TECHNICAL EVALUATION OF THE  
DETAILED CONTROL ROOM DESIGN REVIEW  
FOR  
WISCONSIN PUBLIC SERVICE CORPORATION'S  
KEWAUNEE NUCLEAR POWER PLANT

March 14, 1986

U.S. Nuclear Regulatory Commission  
Washington, D.C. 20555

Science Applications International Corporation  
1710 Goodridge Drive  
McLean, Virginia 22102

Figure 1- Design Modification Process

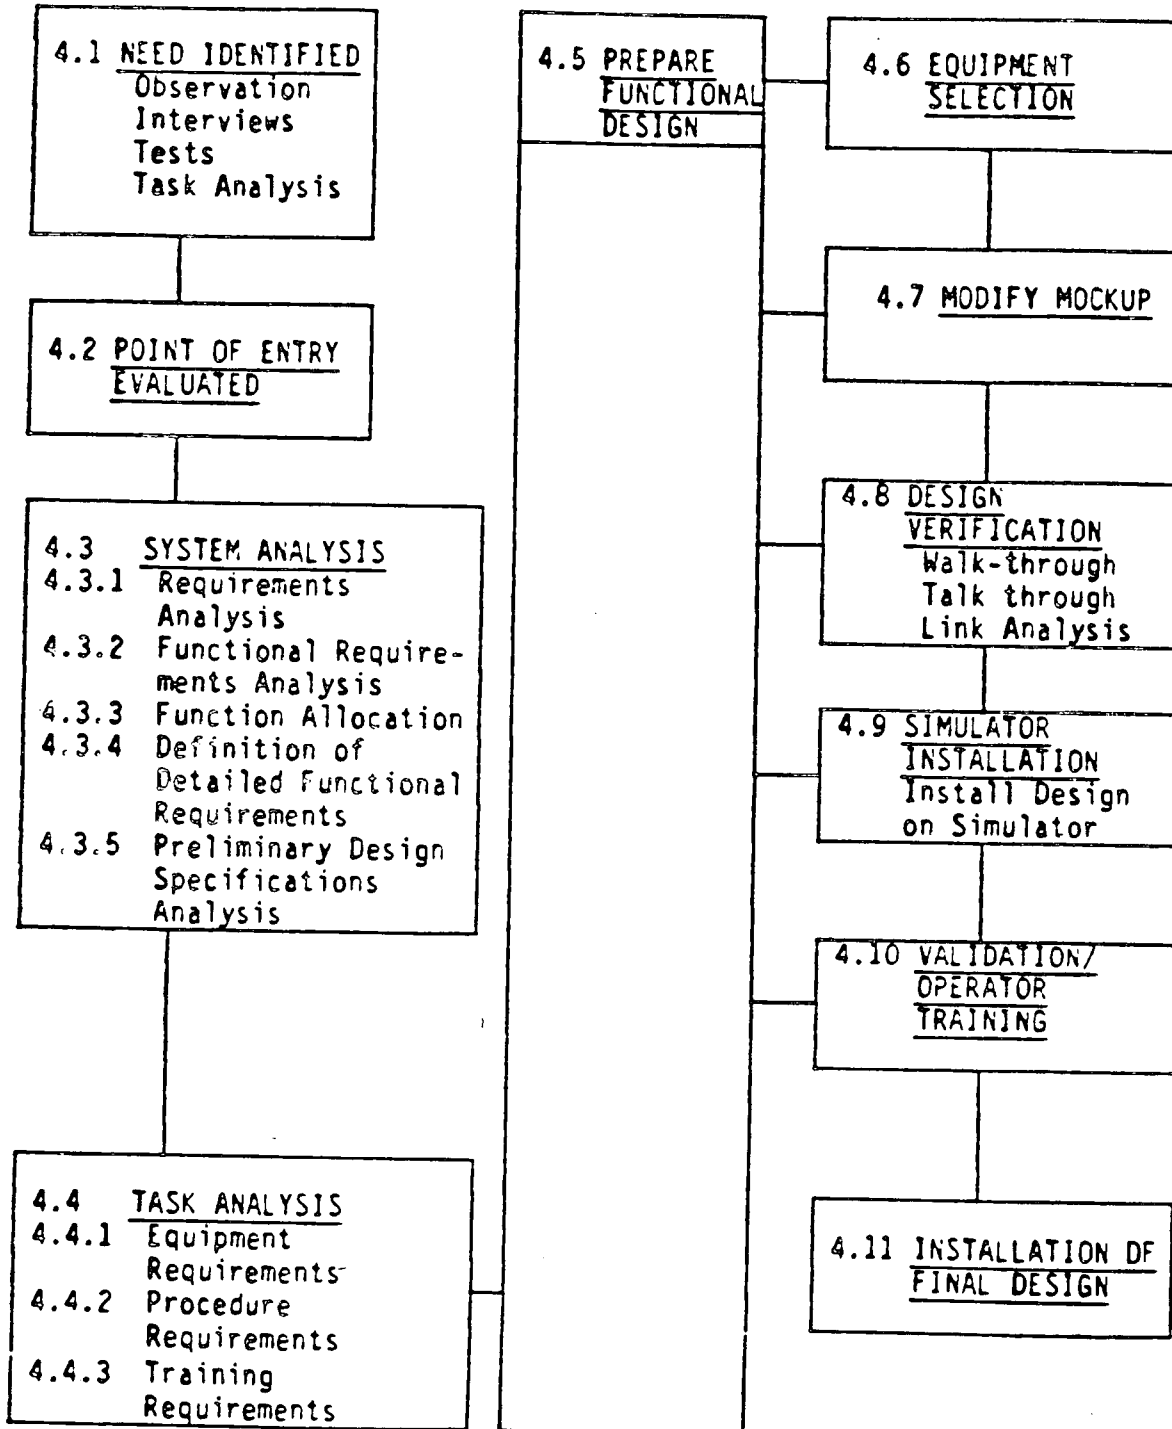
In order to address the NRC/SAIC concerns regarding the selection of design improvements, the licensee prepared a Human Engineering Review Process for Control Room Modifications flow chart (See Figure I). This flow chart was presented by the DCRDR team to the NRC at the February 12, 1986, meeting (Reference 2). The steps in the design modification process are as follows:

In an effort to resolve this concern, the licensee presented a "draft" flow chart and description of the verification process at the February 12, 1986, meeting (Reference 2). The Design Modification Process flow chart (see Figure 1) illustrates the process that will be followed to verify that the modification corrects the HED and does not introduce new HEDs. This flow chart will be part of Engineering Control Procedure No. 4.2, "Human Engineering Review Process for Control Room Modifications." The verification process, as described by the licensee and illustrated in the flow chart, should satisfy the requirements of Supplement 1 to NUREG-0737.

In summary, the verification processes outlined in draft form, should satisfy this Supplement 1 to NUREG-0737 requirement. However, the licensee should provide a description of the final Engineering Control Procedure 4.2 in the Supplement to the Summary Report.
